PROPOSED CHANGE NOTICE

Affected Document: IS-GPS-705 Rev F	IRN/SCN Number XXX-XXXX-XXX	Date: DD-MMM-YYYY
---	---------------------------------------	-----------------------------

Authority: RFC-00395	Proposed Change Notice IS705F-RFC395	Date: 31-MAY-2019
--------------------------------	--	-----------------------------

Document Title: Navstar GPS Space Segment/User Segment L5 Interfaces

Figure 20-1. Message Type 10 - Ephemeris 1

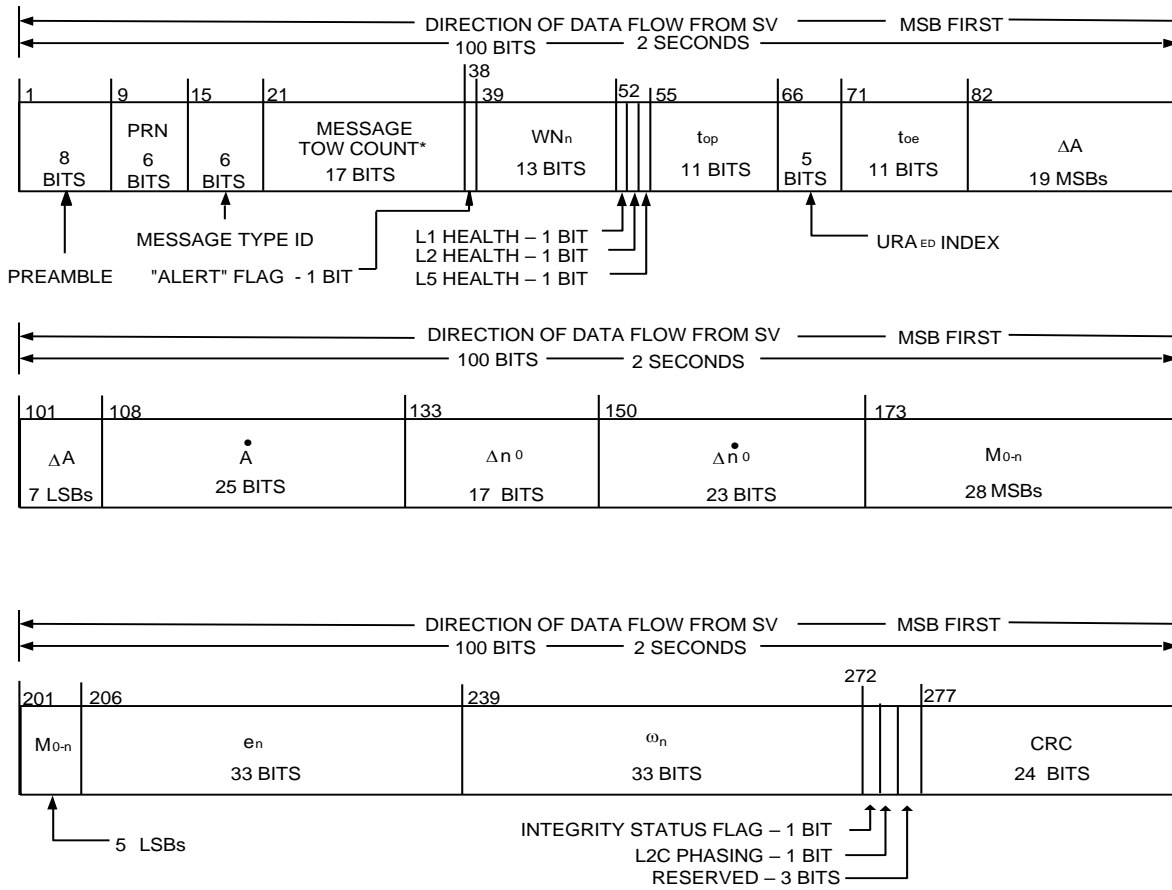
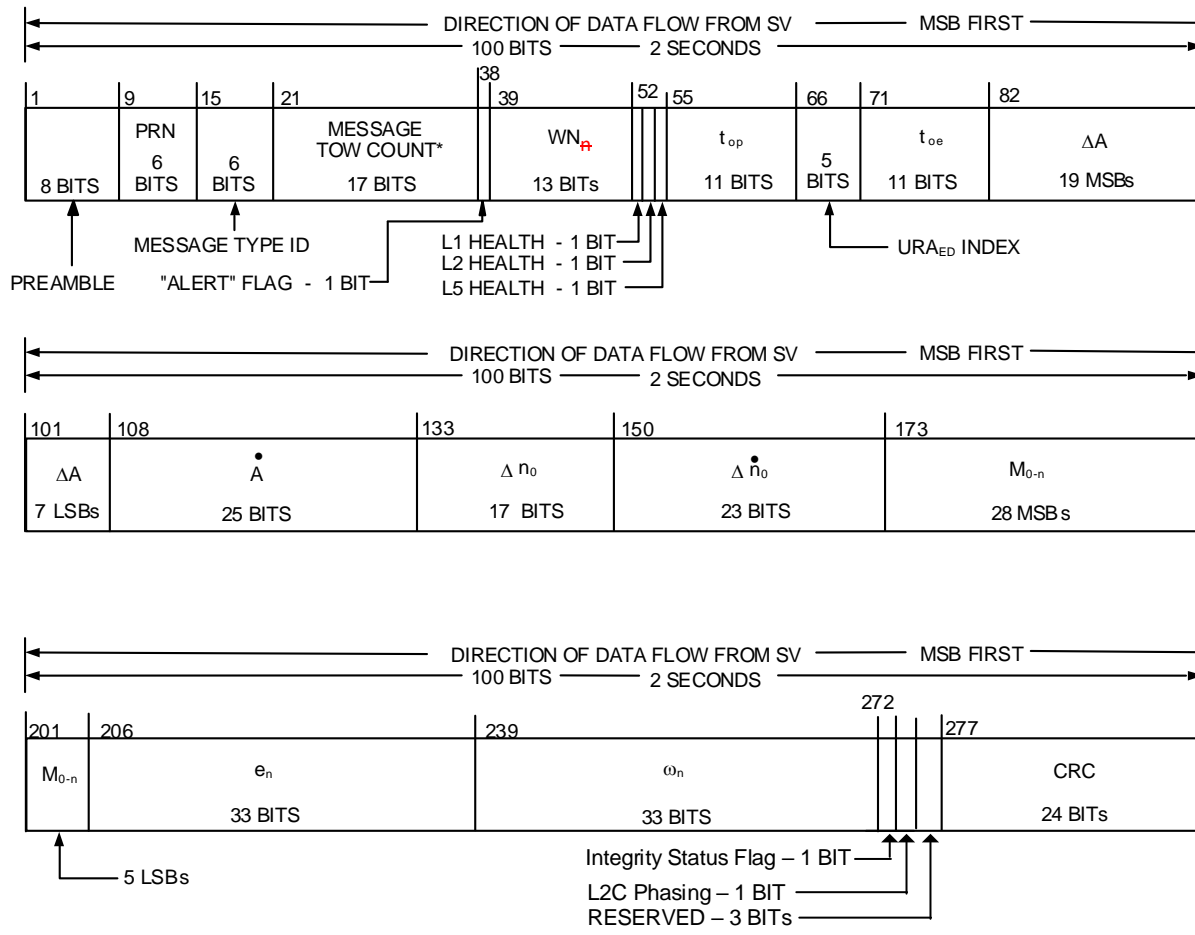
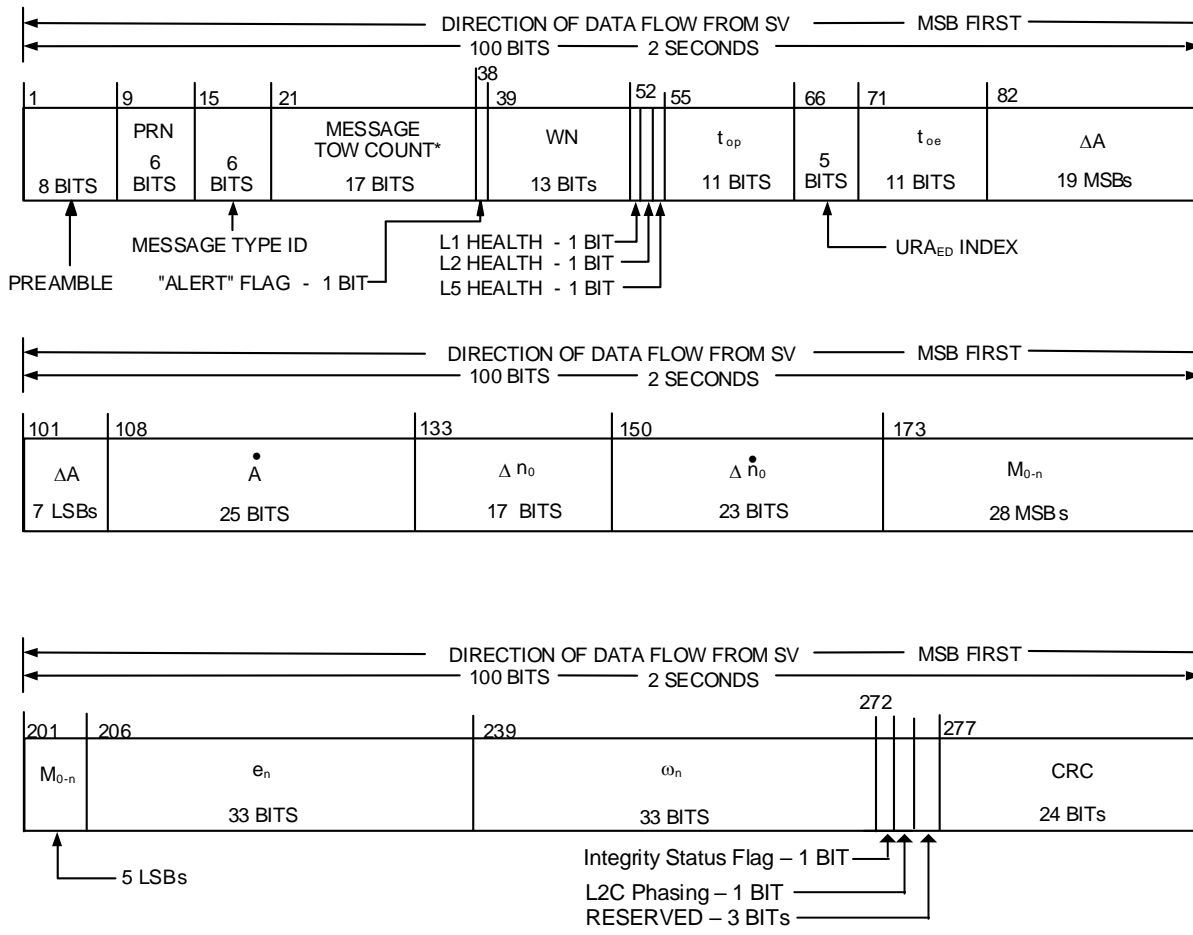
WN_n is not consistently used throughout the document. Remove subscript n from WN_n from table and figure to maintain consistency.
